25-89 CHENERY STREET

Your building permit application to construct an enclosed breezeway, at 25 Chenery Street is hereby approved subject to the following:

To install 18' x 36' inground pool as per plans.
1 sheet of plans.
send permit to # 1 04103

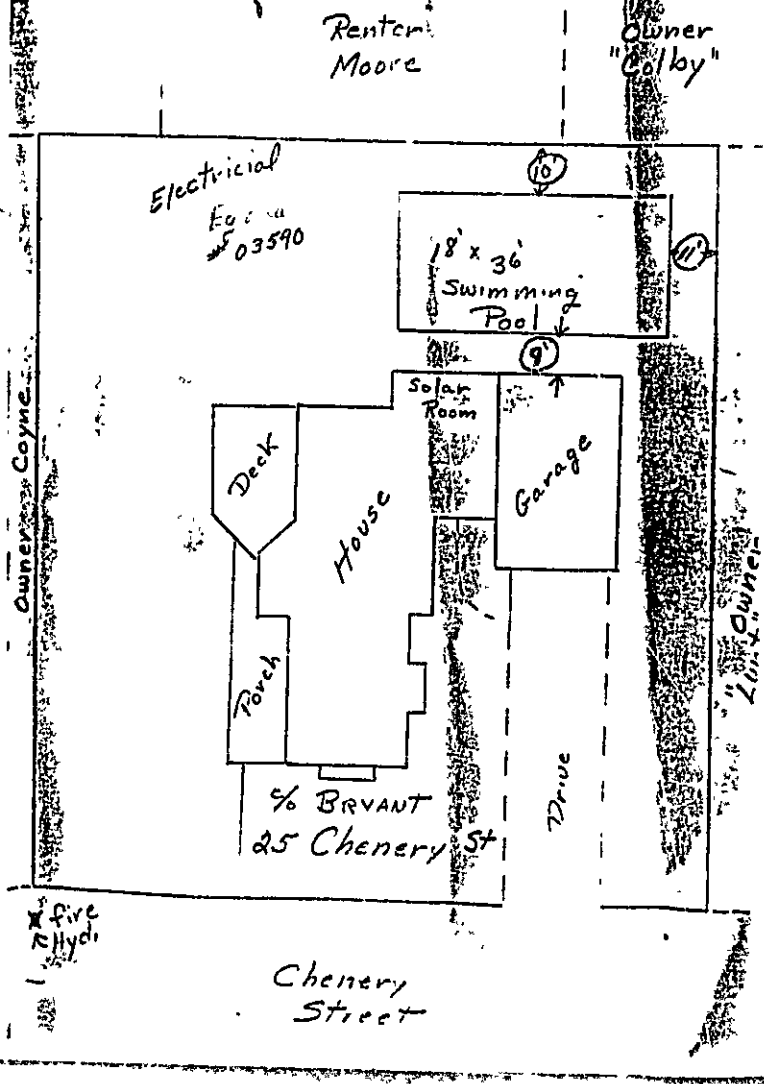
3-6 MEASUREMENTS TAKEN THIS DATE.
 THE SIDE SETBACKS FALL 4"
 SHORT OF THE REQUIREMENTS.
 Peter Bryant
 WILL INFORM WST.
 TW 772-2017

3-7 WST STATED HE WANTS
 BE CONCERNED ABOUT WANTS YOU TO CALL BEFORE
 4". CAUSED OWNER YOU COME OUT TO MEASURE
 + INFORMED HIM HIS REAR YARD AS HE WANTS
 TO SEEK A VARIANCE IF IT IS
 NECESSARY.

Should have
 10' setback on
 all sides of
 the proposed
 swimming
 pool.
 WST

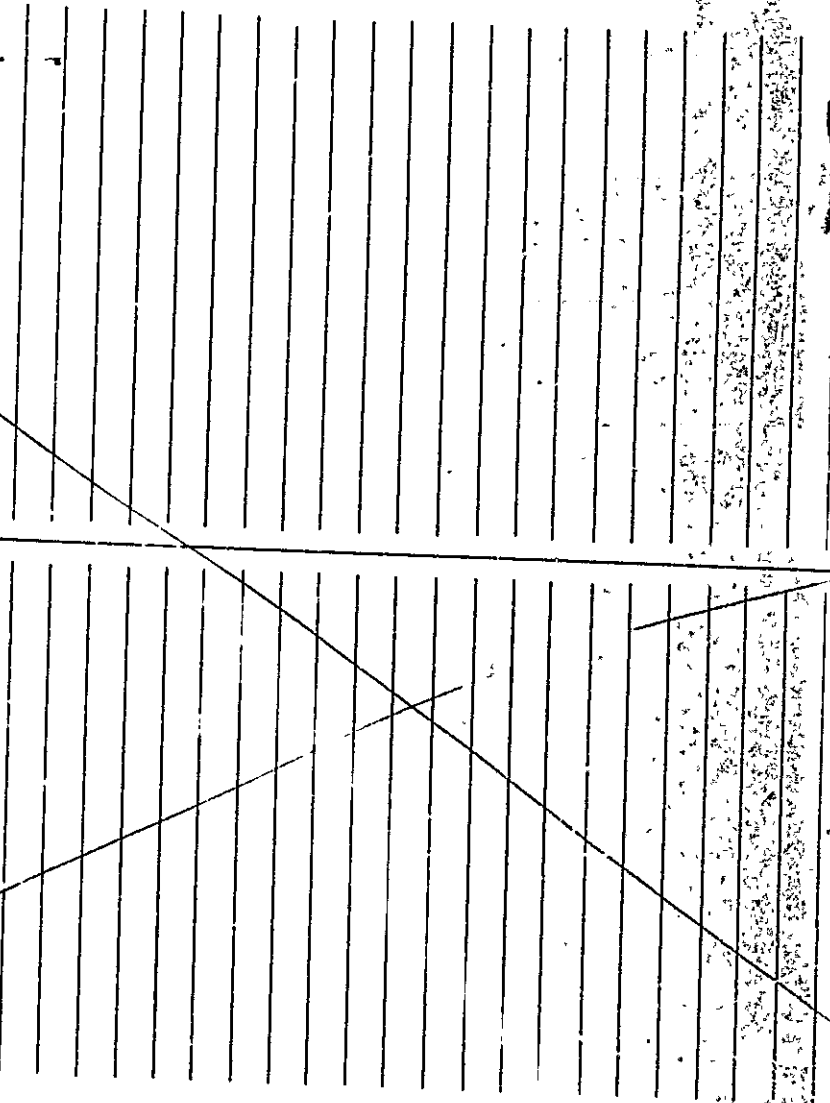
3-6 MEASUREMENTS TAKEN THIS DATE.
 THE SIDE SETBACKS - ALL 4"
 SHORT OF THE REQUIREMENTS.
 Peter Bryant
 WILL INFORM WST.
 To 772-2017

3-7 WST STATED THE WORK
 BE CONCERNED ABOUT WANTS YOU TO CALL BEFORE
 4". CAUSED OWNER YOU COME OUT TO MEASURE
 + INFORMED HIM HIS REAR YARD AS HE WANTS
 TO SEEK A VARIANCE IF IT IS
 NECESSARY.

Should have
 10' setback on
 all sides of
 the proposed
 swimming
 pool.
 W.S.T.
